TURKEY POINT NUCLEAR GENERATING STATION UNIT 3 AND UNIT 4

IMPROVED TECHNICAL SPECIFICATIONS CONVERSION

ITS SECTION 3.4 REACTOR COOLANT SYSTEM (RCS)

Revision 1

FIGURE 3.4-2 Turkey Point Units 3 & 4 Reactor Coolant System Heatup Limitations (Heatup Rates of 60 and 100°F/hr) Applicable for 48 EFPY (Without Margins for Instrumentation Errors)

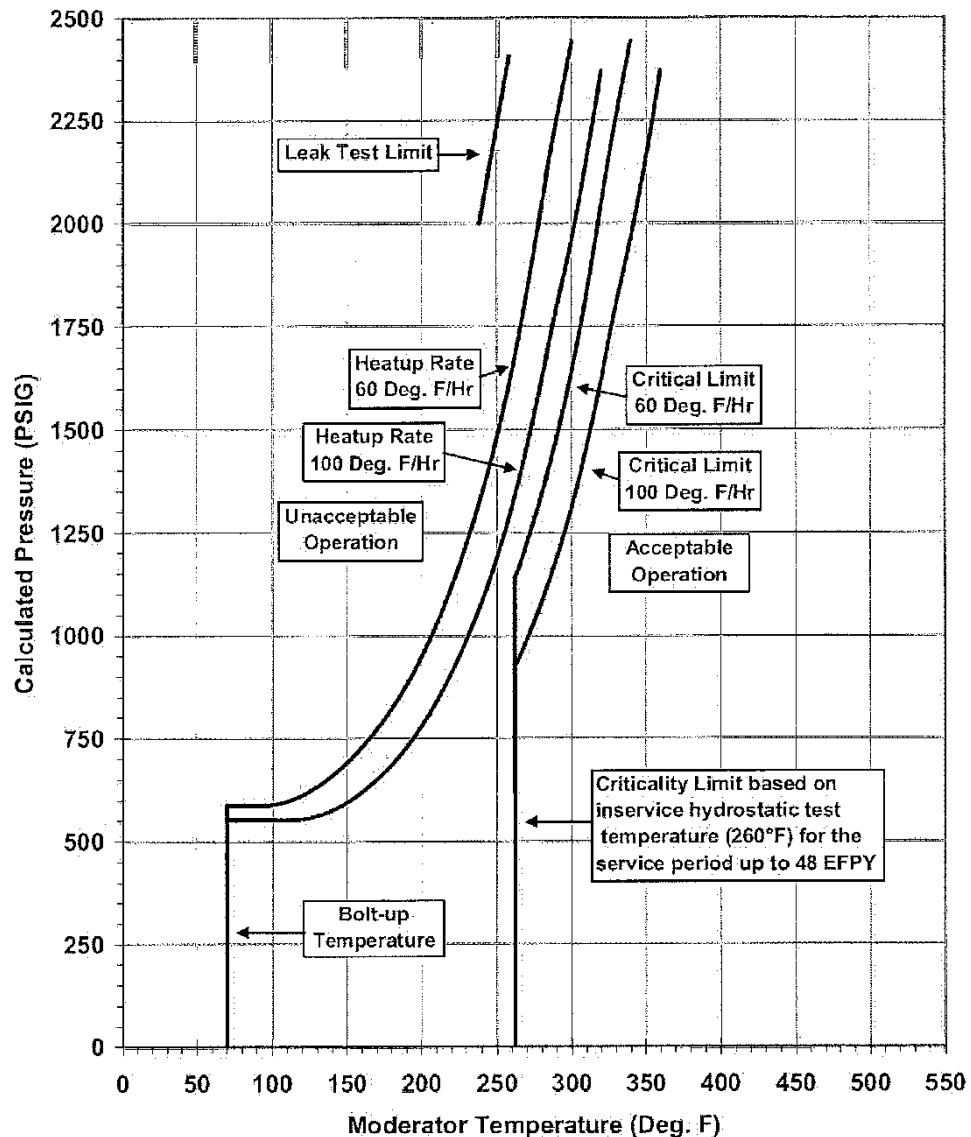
A01

A01

The removal of the "Material Property Basis" information from the aforementioned Technical Specification figures is acceptable because this type of information is not necessary to be included in the Technical Specifications to provide adequate protection of public health and safety. This change is acceptable because these types of procedural details will be adequately controlled in the Updated Final Safety Analysis Report (UFSAR) and any changes to the UFSAR are made under 10 CFR 50.59, which ensures changes are properly evaluated. This change is designated as a less restrictive because the details of material properties on which the associated graphs are based is being removed from the Technical Specifications.

FIGURE 3.4-3 Turkey Point Units 3 & 4 Reactor Coolant System Cooldown Limitations (Cooldown Rates of 0, 20, 40, 60 and 100°F/hr) Applicable for 48 EFY (Without Margins for Instrumentation Errors)

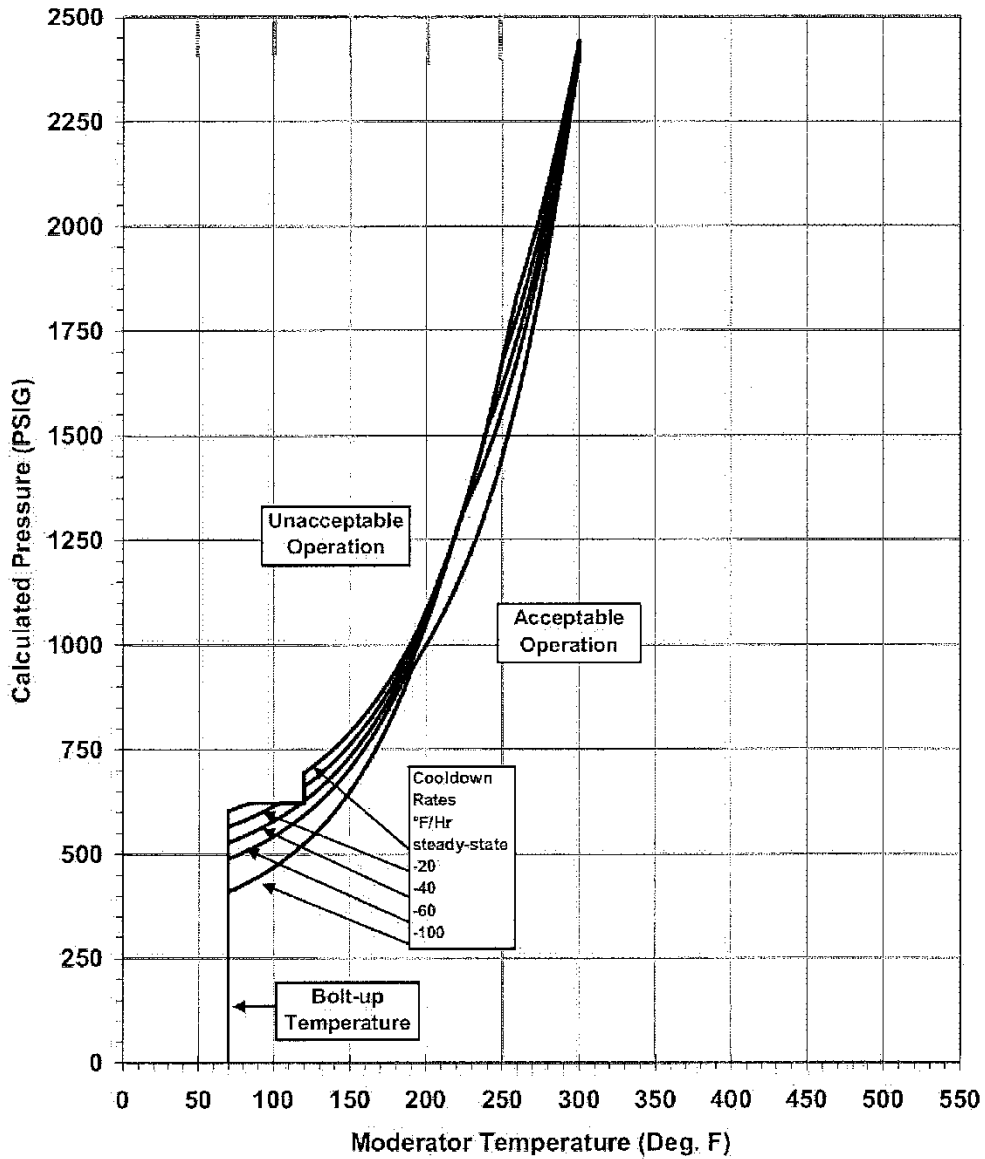
A01
